Attachment 10 to Memorandum #7: Statement of Rob Greenaway

Date	21 January 2026
To	Jon Bright, Project Director – Waitaha Hydro Scheme Westpower Ltd
From	Rob Greenaway
Project advice provided for	<i>Waitaha Hydro Scheme</i>
Documents referred to	<i>Waitaha Hydro Scheme Substantive Application Appendix 28 Recreation Report</i>
Experience	Recorded in Appendix 28 Recreation Report
Code of Conduct	Appendix A
Signature

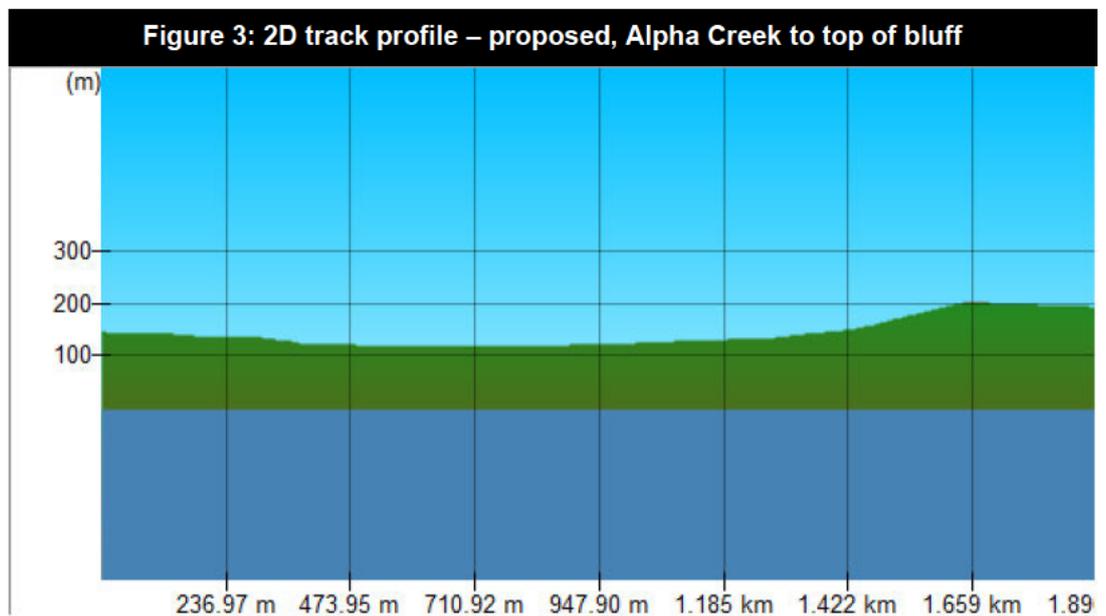
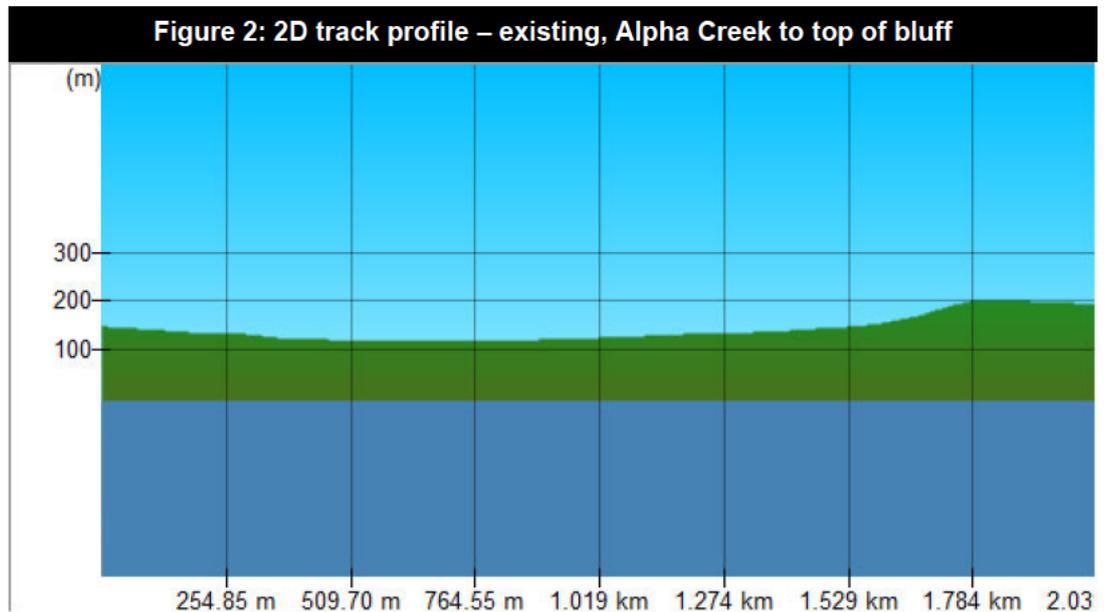
30. In addition to higher compensation, the DOC Recreation Report recommends that Westpower reinstate the track on the true left bank of the Waitaha River because it considers the proposed alternative track (to minimise views of construction) does not effectively reduce exposure to the Power Station site (paragraphs 11 and 47).
31. There appears to be some misunderstanding about the alternative proposed track. The location of the proposed deviation to the access track is shown in Figure 11 of the Boffa Miskell Landscape Assessment (Part A of the Graphic Supplement). I have reproduced this in my Figure 1 below. This shows a

marginal change in total track distance (a reduction of 100m) and no fundamental change in terrain.

32. Figure 2 (existing) and Figure 3 (proposed) compare the altitude profiles of the two track alignments shown in Figure 1. These are virtually identical, which stands to reason considering they rely on the same river-flat to access the same bluff (which I have traversed several times).

33. The proposed alternative alignment will serve to reduce the potential impact of views of the Power Station and has no impact on the total recreation experience or difficulty. Accordingly, I consider the mitigation as proposed by Westpower to be appropriate.
34. Further, the recommendation by the DOC Recreation Report to reinstate and maintain the original track to Kiwi Flat on the true left of the river for the life of would require the construction of an entirely new track (as from walking part
